Department of Environmental Quality
Division of Radiation Control

SUBJECT: September 2002 Final Site Observational Work Plan for the Green River, Utah
UMTRA Site: DRC Comments

DRC Comments on the September 2002 Final SOWP

**July 2002 Potentiometric Surface of Cedar Mountain Middle Sandstone Unit
including water level in well 180
Green River UMTRA Site**

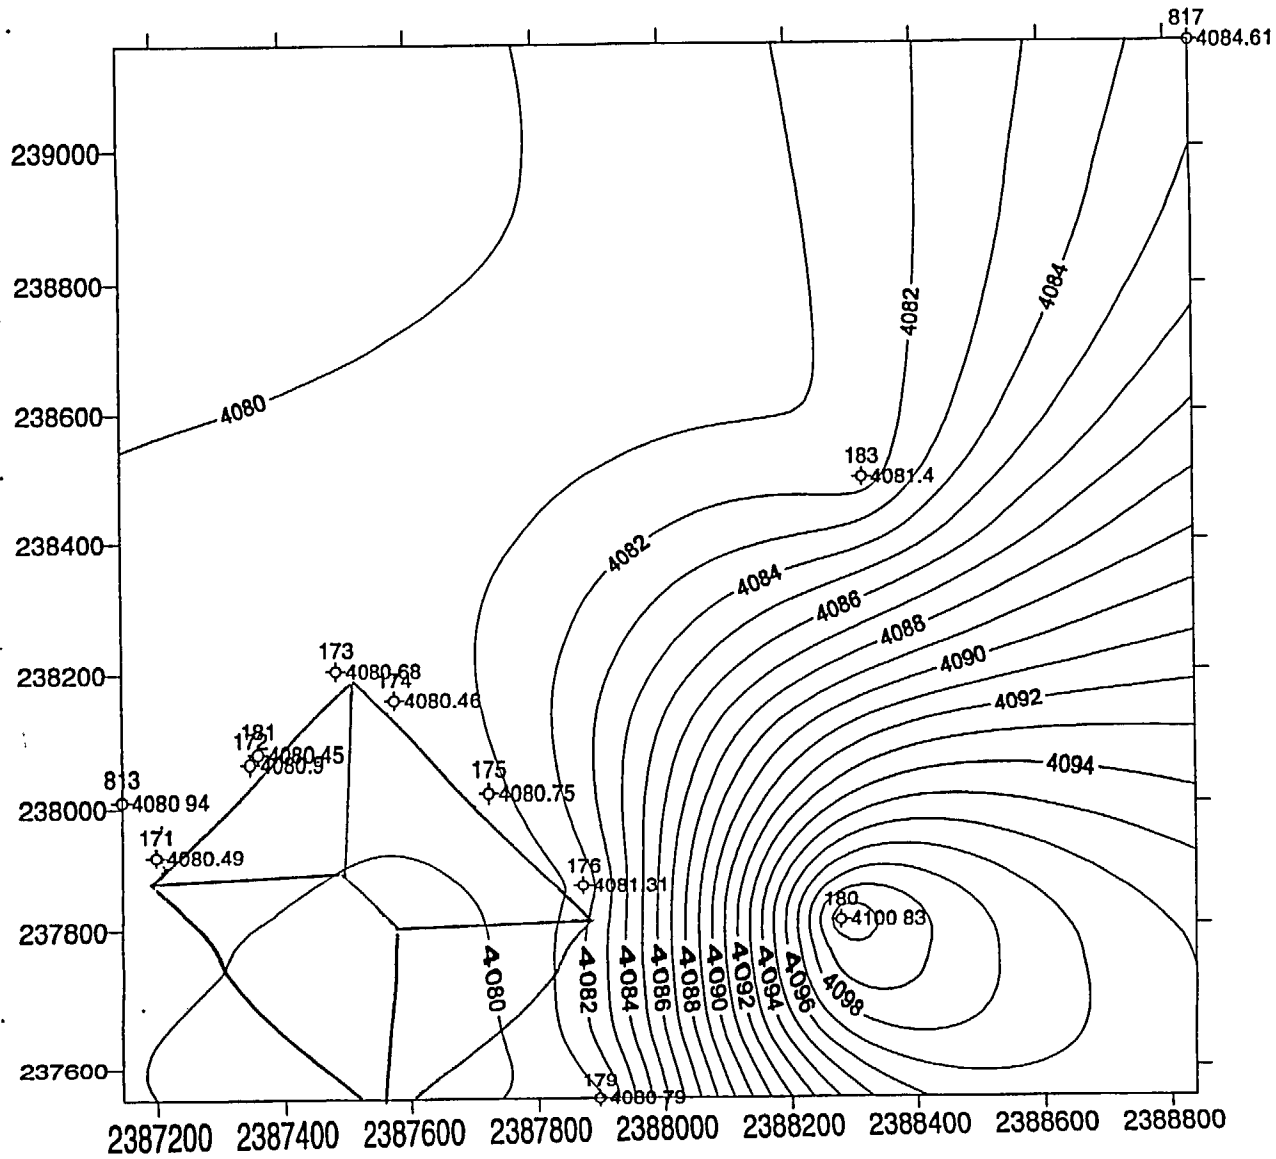
Northwest Hydraulic Gradient. After constructing a series of cross sections and correlating the sandstone units beneath the site, DRC staff constructed a map of the potentiometric surface for the middle sandstone unit of the Cedar Mountain Formation (Attachment 1). The data used for this map are summarized in Table 1 below with other hydrogeologic data.

The hydraulic gradient in Attachment 1 is consistent with the hydraulic gradient provided by the DRC in 1996 (Attachment 2). Both DRC maps include well 0180 as a data point and show an overall northwestward flow direction with a relatively flat hydraulic gradient in the vicinity of the disposal cell and a steep gradient east of the disposal cell. It is interesting to note that the hydraulic head in well 0180 has changed very little in seven years from a value of 4100.95 feet amsl in June 1995 to a value of 4100.83 in July 2002. Geologic cross sections and boring log correlations indicate that the well screens in monitoring wells 0177 and 0178 are completed in a different sandstone aquifer, referred to by DOE as lenticular stringer sandstones of the lower unit of the Cedar Mountain Formation. Based on lithologic descriptions, stratigraphic position, and geochemical signatures, the DRC concurs that the lower Cedar Mountain stringer sandstone aquifer is hydraulically connected with the Cedar Mountain basal sandstone unit, but hydraulically separated from the Cedar Mountain

middle sandstone unit. As a result, water levels for wells 0177 and 0178 were not included in the July 2002 potentiometric surface of the Cedar Mountain middle sandstone unit (Attachment 1).

The northwest hydraulic gradient depicted in Attachment 1 is supported by fracture and joint patterns at the Green River site and the structural dip of the middle sandstone unit. Figure 5-6 of the Final SOWP indicates a predominant northwest orientation of fractures and joints at the Green River site, which supports a northwest groundwater flow direction. In addition, a structure contour map constructed on top of the middle sandstone unit indicates a northern structural gradient with a slight northwest dip component in the vicinity of the disposal cell (Attachment 4). The combination of a northern structural gradient with a northwest fracture orientation is consistent with the northwest hydraulic gradient in Attachment 1.

If the hydraulic gradient is to the northwest as indicated by DRC Attachment 1, proposed POC wells 0171, 0173, 0181, and 0813 are adequate locations for monitoring ACLs for the Cedar Mountain middle sandstone unit. Although proposed POE well 0182 is in an appropriate location for a northwest hydraulic gradient, this well is screened across the basal sandstone unit of the Cedar Mountain Formation, not the middle sandstone unit. Because the basal sandstone unit of the Cedar Mountain Formation has a strong upward hydraulic gradient and is hydrogeologically isolated from the middle sandstone unit, it has not been contaminated by site-related activities. As a result, well 0182 cannot serve as a POE well for the Cedar Mountain middle sandstone unit. Therefore, a POE well needs to be installed near the downgradient edge of the State property boundary with a screened interval across the middle sandstone unit of the Cedar Mountain Formation.

July 2002 Potentiometric Surface of Cedar Mountain Middle Sandstone Unit
excluding water level in well 180
Green River UMTRA Site

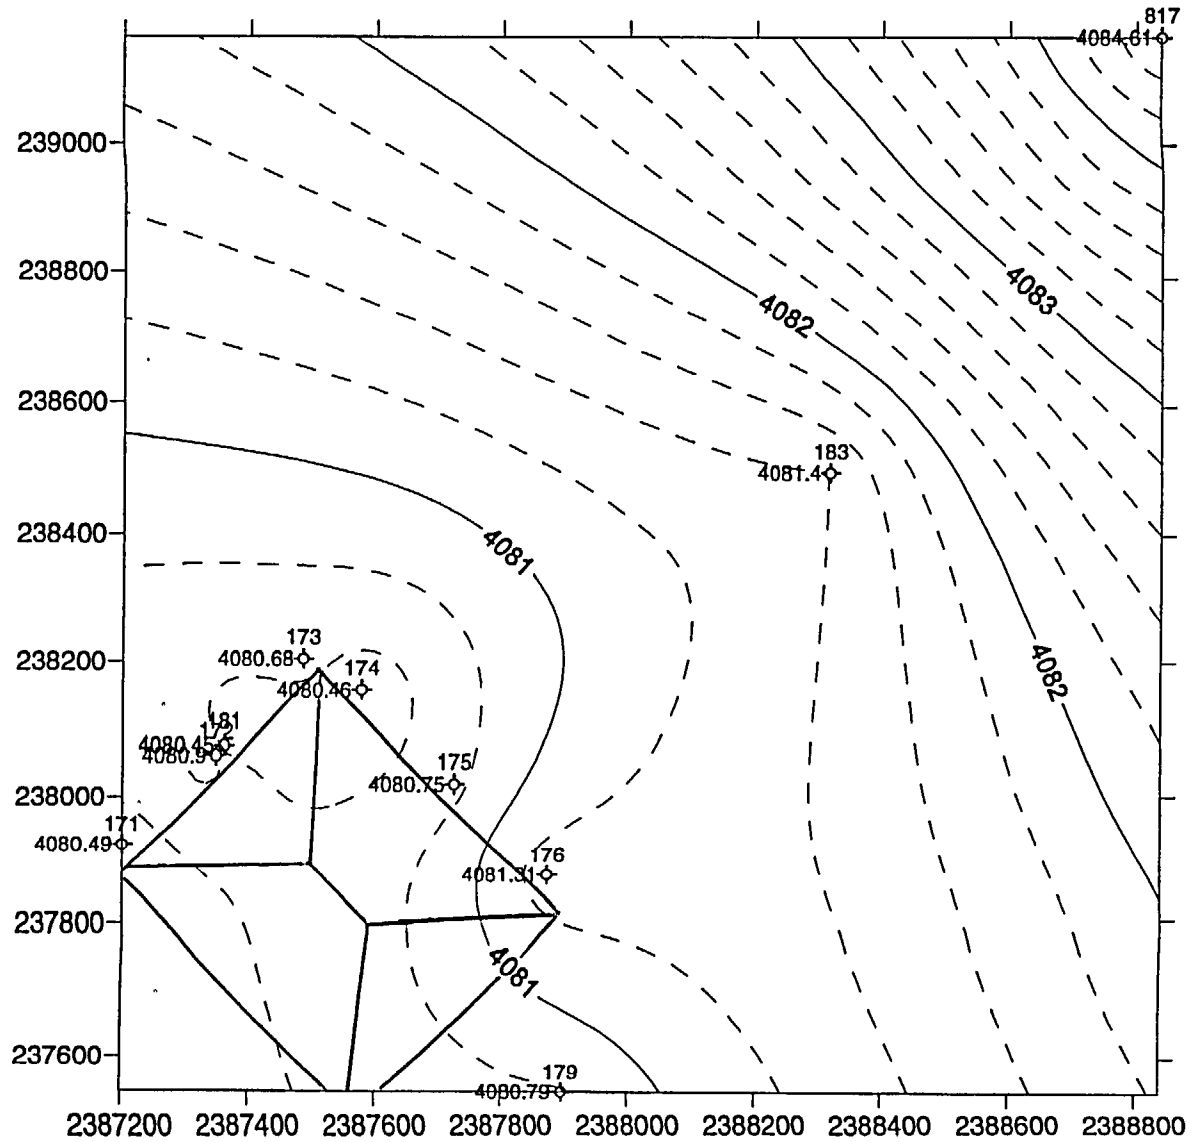
Southwest Hydraulic Gradient. Figure 5-9 of the Final SOWP depicts a southwest hydraulic gradient towards the Green River regional discharge area. The difference between the potentiometric surface depicted in DRC Attachment 1 and Figure 5-9 of the Final SOWP is caused by the presence or absence of the head measurement in well 0180. The DRC map in Attachment 1 includes the head elevation in well 0180 while Figure 5-9 of the Final SOWP does not. By removing the head measurement of well 0180 from the data set, DRC staff replicated the potentiometric surface in Figure 5-9 of the Final SOWP (Attachment 3). However, correlations of boring logs in DRC cross sections show that the middle sandstone unit of the Cedar Mountain Formation is present in well 0180 from 4079.20 and 4067.20 feet elevation above mean sea level (amsl). This sandstone correlates with the sandstone present from 4113.70 to 4073.70 feet amsl in well 0179 to the southwest, and the sandstone present from 4030.00 and 4011.00 feet amsl in well 0183 to the northeast. Because wells 0179, 0180, and 0183 are all completed in the middle sandstone unit of the Cedar Mountain Formation, the water level elevation measured in well 0180 should be included in the potentiometric surface map for the middle sandstone unit of the Cedar Mountain Formation.
